Federal Emergency Management Agency

Case No.: 08-01-0505P
Community Name: City of Bristol, CT
Community No.: 090023
Effective Date of
This Revision: **June 11, 2008**

LETTER OF MAP REVISION DETERMINATION DOCUMENT

Flooding Source	Effective Flooding	Revised Flooding	Increases	Decreases
Pequabuck River	Zone A1-A30	Zone A1-A30	NONE	YES
	BFEs*	BFEs	NONE	YES
	Floodway	Floodway	NONE	YES

TABLE 2

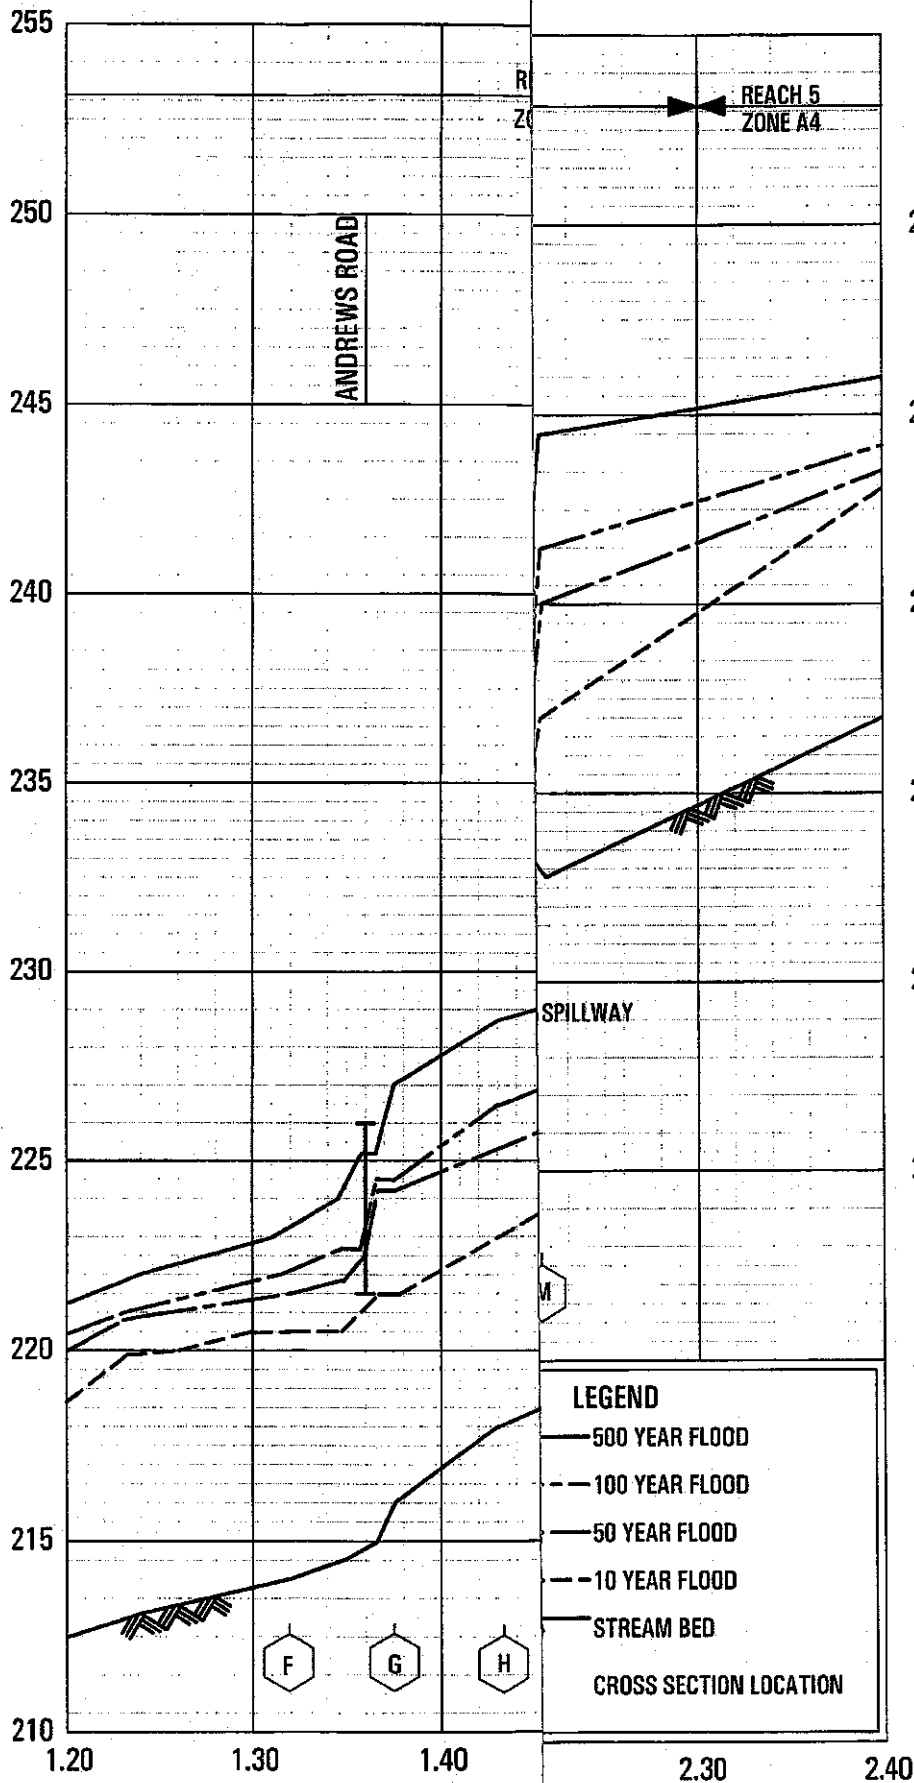
Q	3.644	60	692	6.1	313.1	313.1	313.2	0.1
R	3.993	60	368	11.4	328.0	328.0	328.0	0.0
S	4.201	220	1,126	3.7	352.0	352.0	352.5	0.5
REVISED BY LOMR EFFECTIVE MARCH 16, 1998					REVISED TO REFLECT LOMR EFFECTIVE: June 11, 2008			
REVISED DATA

FLOOD PROFILES

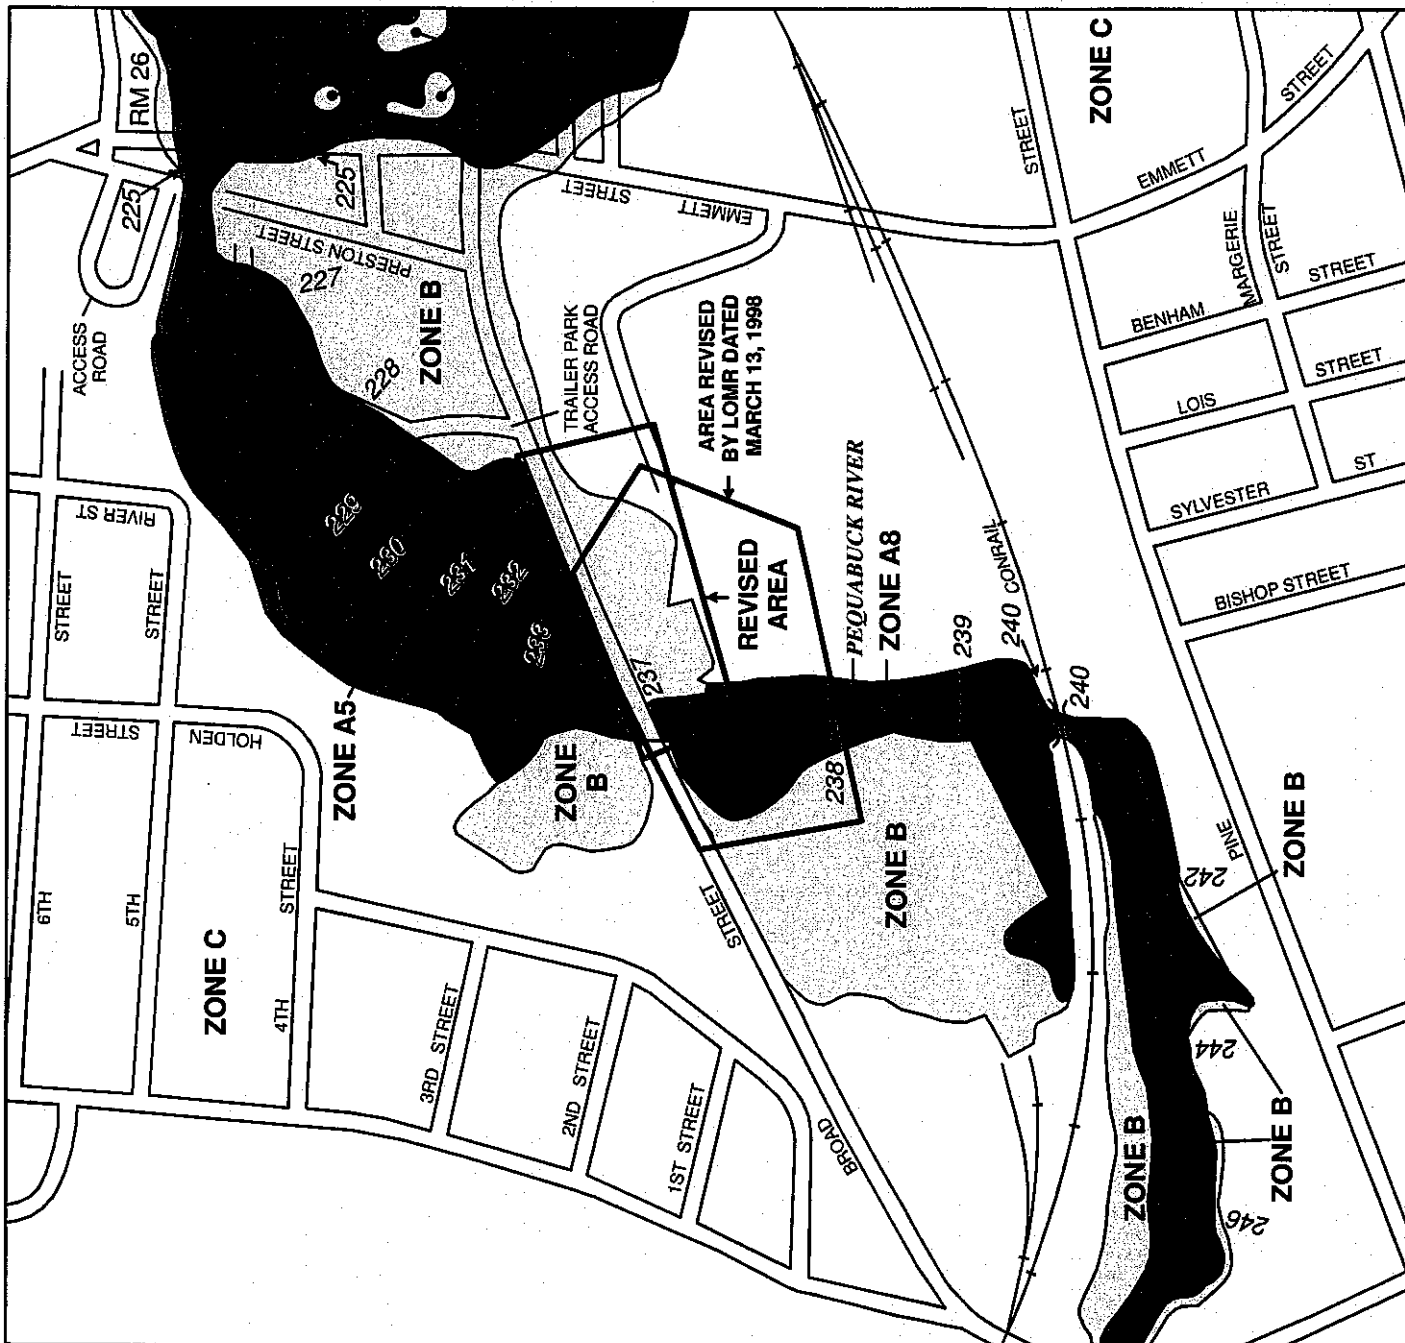
REVISED TO
REFLECT LOMR

FIRM
FLOOD INSURANCE RATE MAP

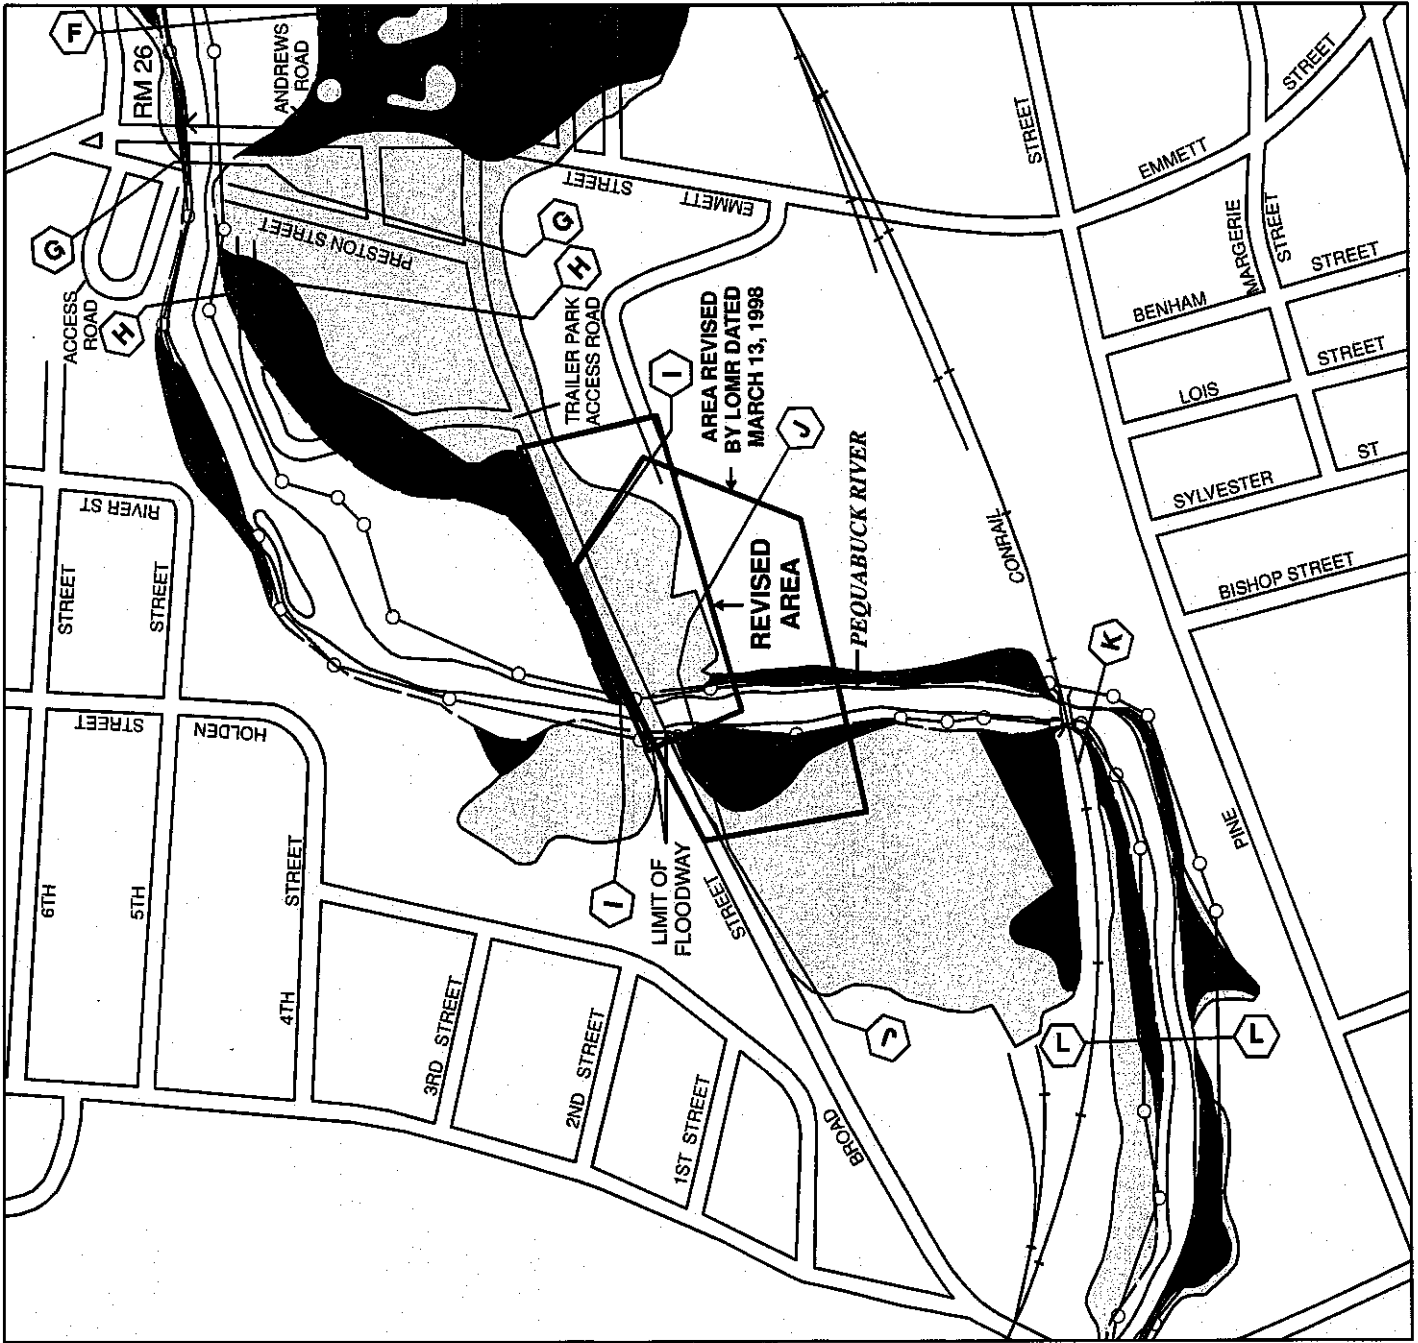
**REVISED TO
REFLECT LOMR
EFFECTIVE: June 11, 2008**

FLOODING SOURCE	LOCATION OF REFERENCED ELEVATION	BFE (FEET NGVD 29)		MAP PANEL NUMBER(S)
		EFFECTIVE	REVISED	
Pequabuck River	Just upstream of Broad Street	238	237	0007 B

FLOODWAY DATA

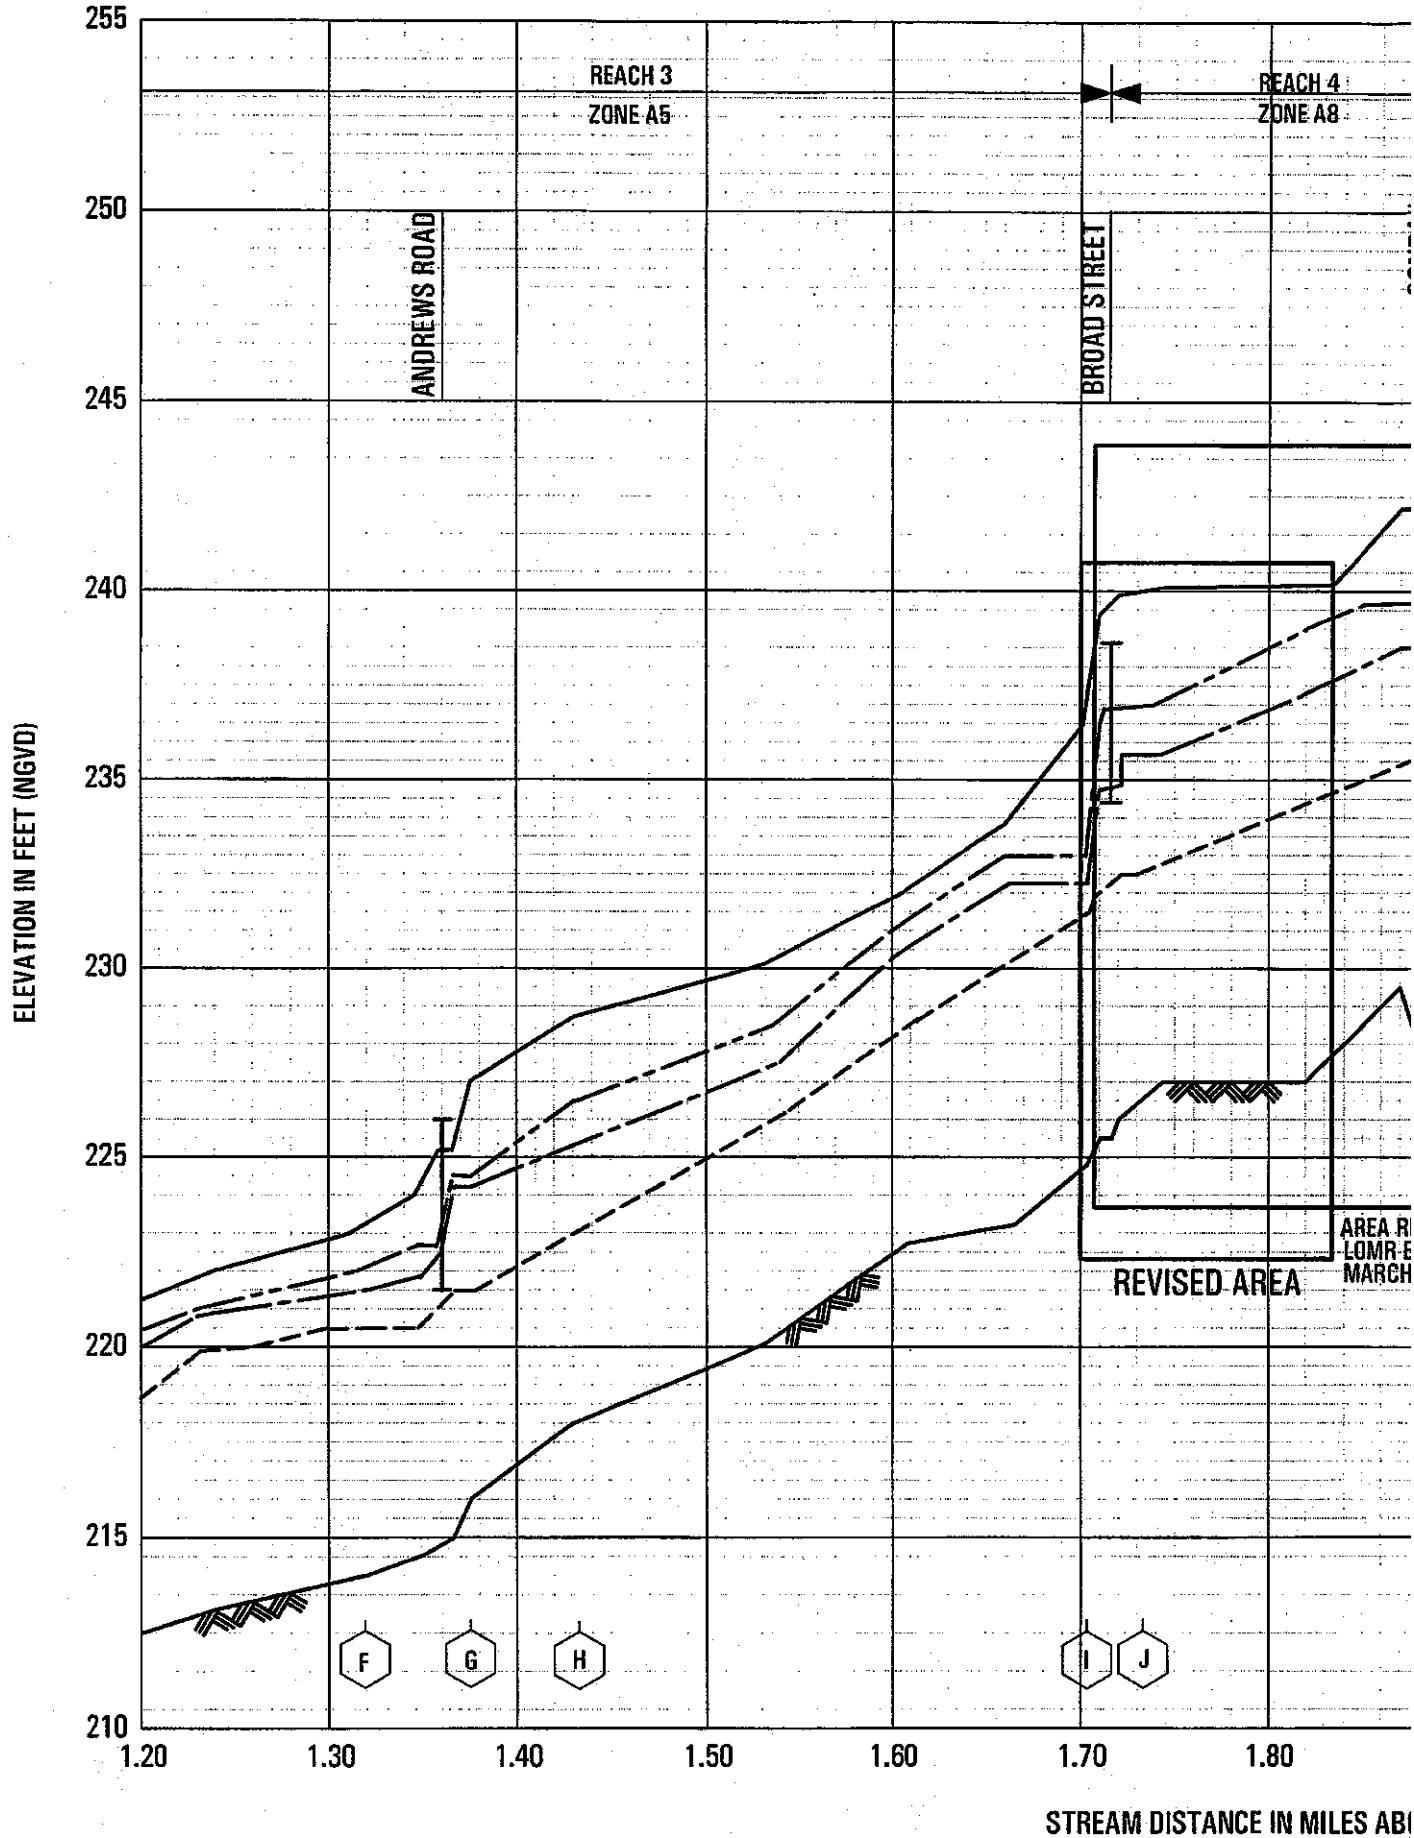
Q	3.644	60	692	6.1	313.1	313.1	313.2	0.1
R	3.993	60	368	11.4	328.0	328.0	328.0	0.0
S	4.201	220	1,126	3.7	352.0	352.0	352.5	0.5
REVISED BY LOMR EFFECTIVE MARCH 16, 1998					REVISED TO REFLECT LOMR EFFECTIVE: June 11, 2008			
REVISED DATA

FIRM
FLOOD INSURANCE RATE MAP

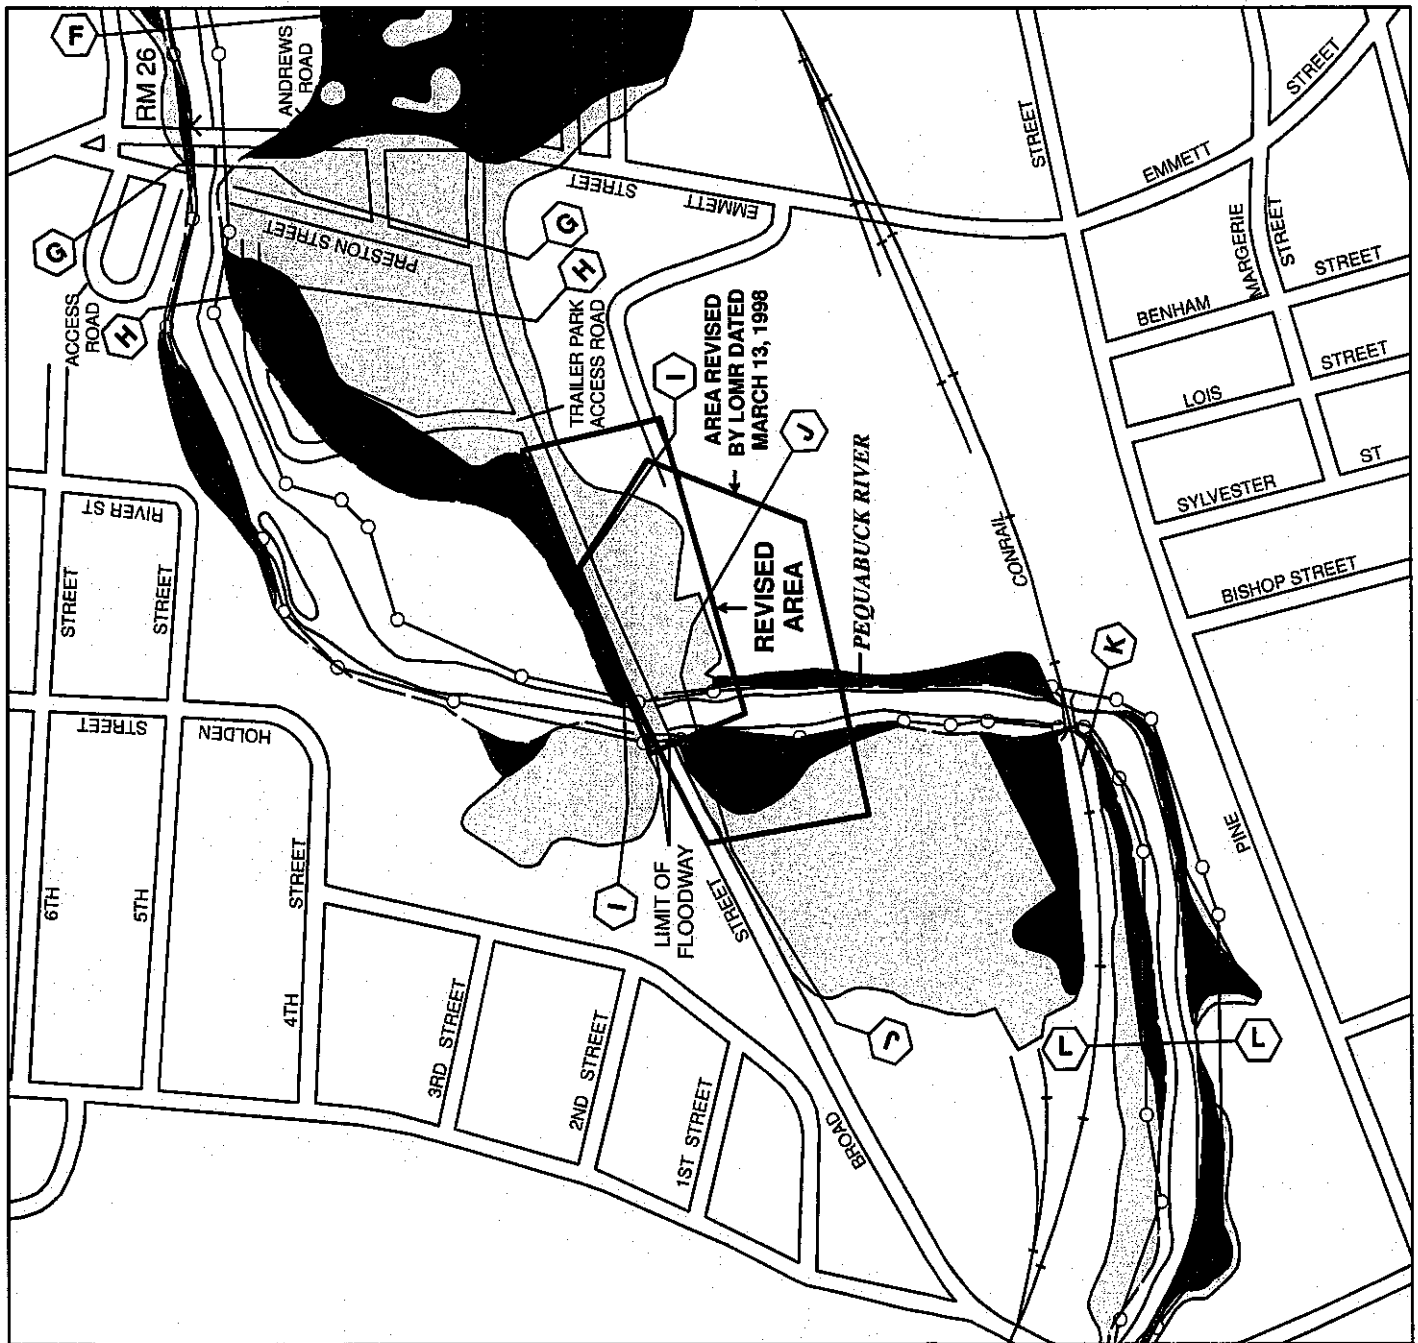
**REVISED TO
REFLECT LOMR
EFFECTIVE: June 11, 2008**
